ADDENDUM NO. 1

Project Designation: 16070 - JJSD #251 Harwood Elementary Addition and Remodel

For: Jefferson Joint School District No. 251

Date: April 29, 2019

SHEET TITLE:
EXISTING ELECTRICAL PLAN

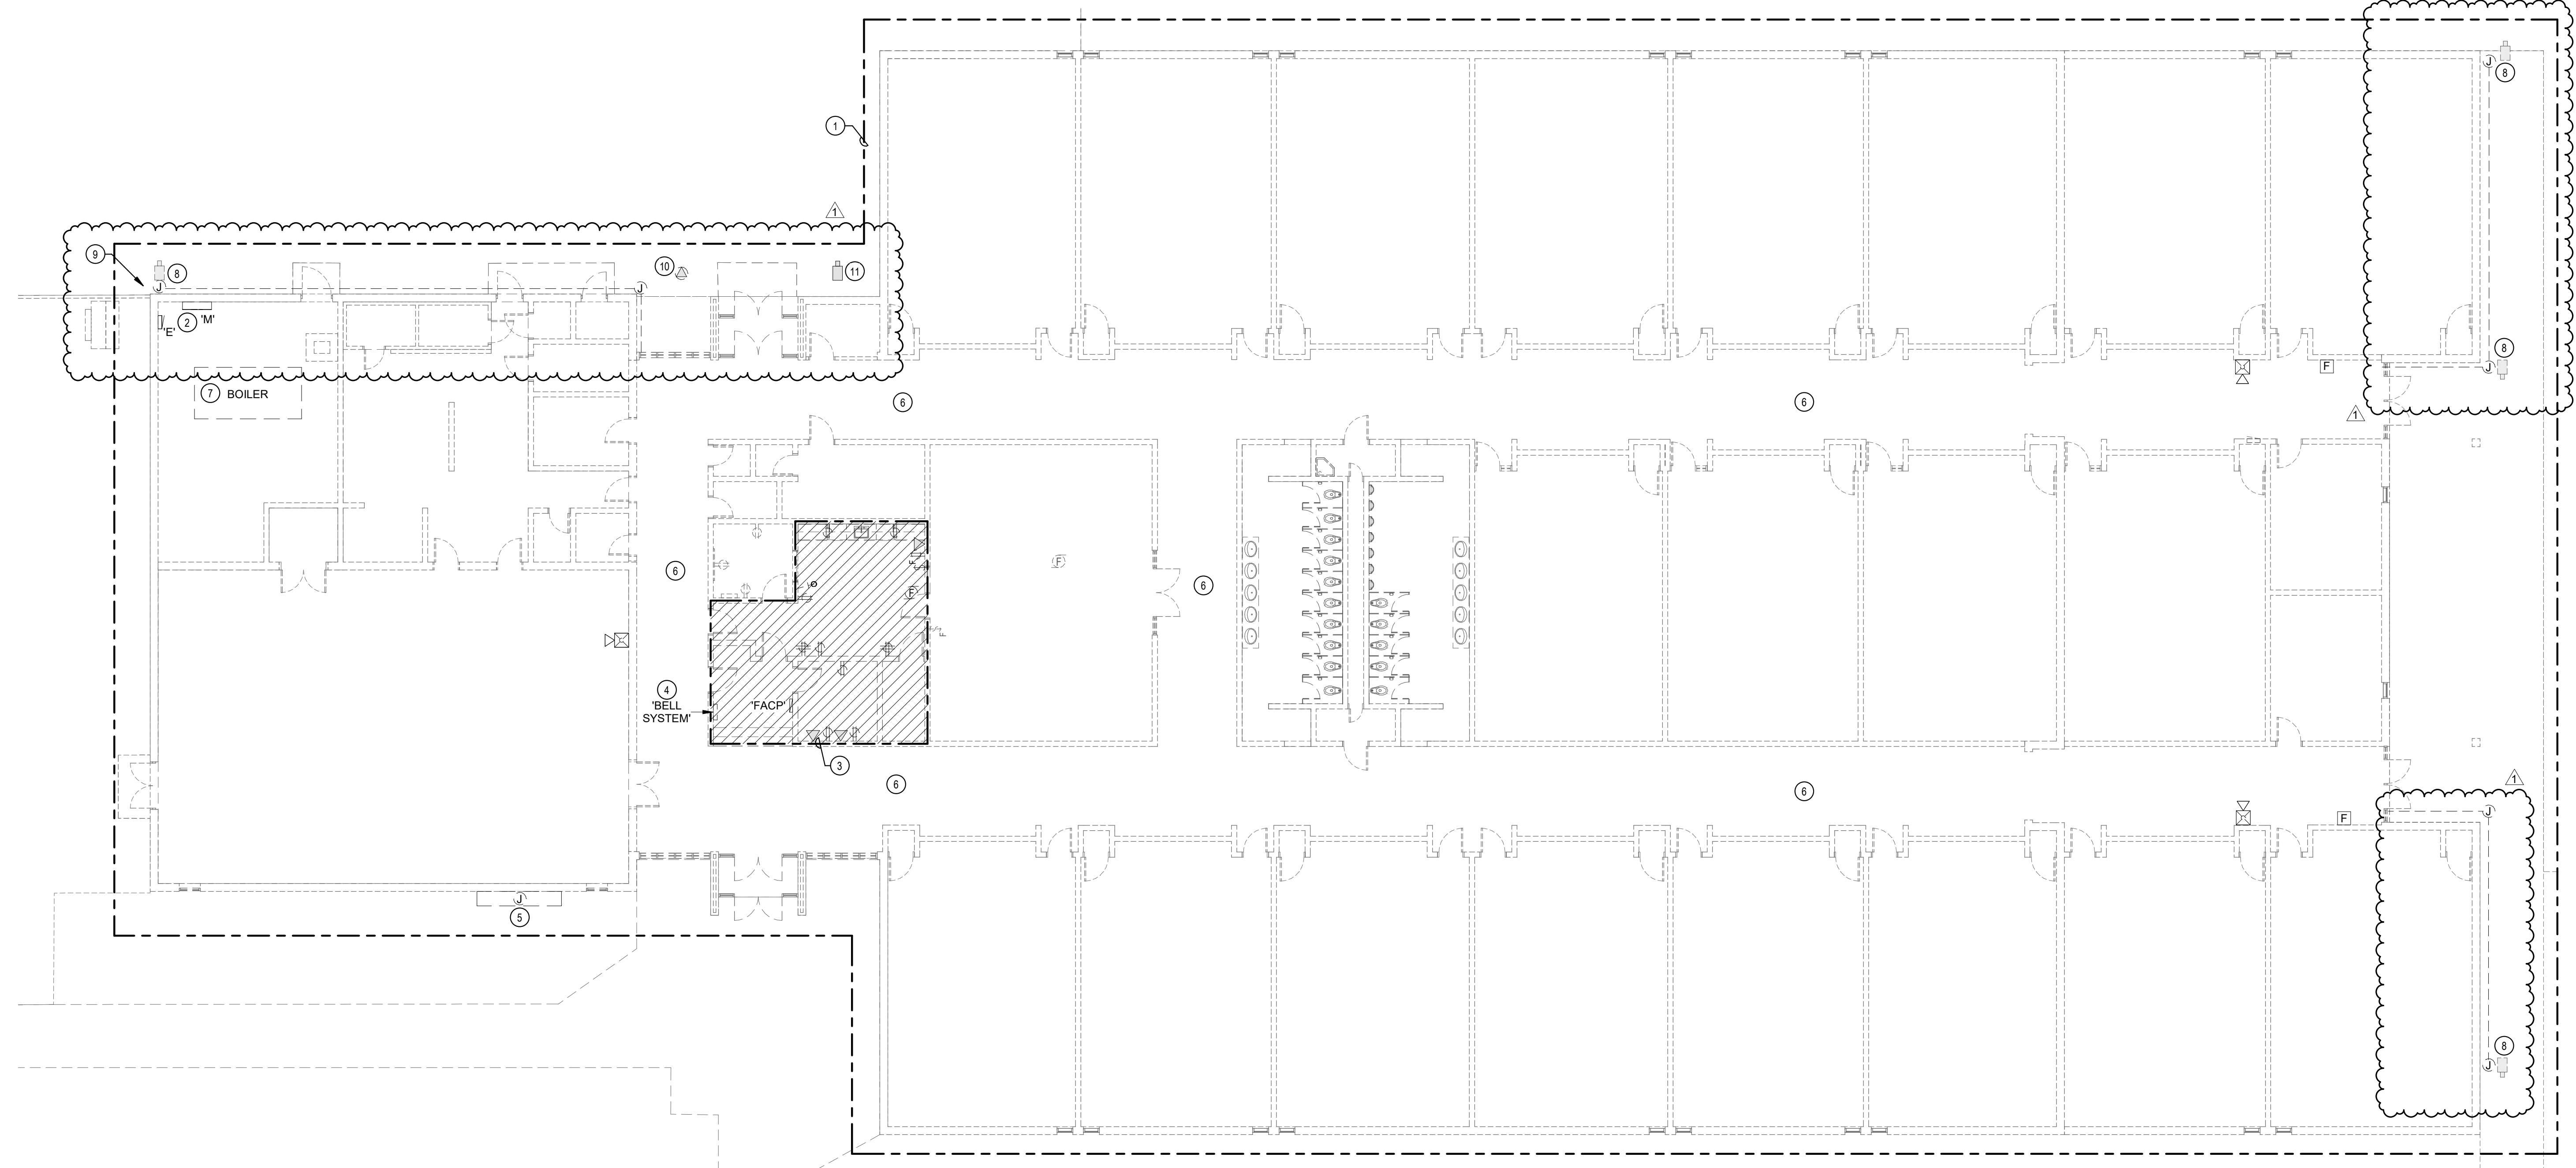
1. See revised sheets **ED1.1, ED1.2, E2.1A, E2.1B, E2.2,** and **E3.2**
 - a. Existing exterior lighting and CCTV cameras are to be replaced or modified as required to accommodate replacement of existing building soffit. Refer to revised drawings.
 - b. New recessed can lights at entry's to existing large restrooms are to be circuited to Corridor lighting circuit and controls. Refer to revised drawings.
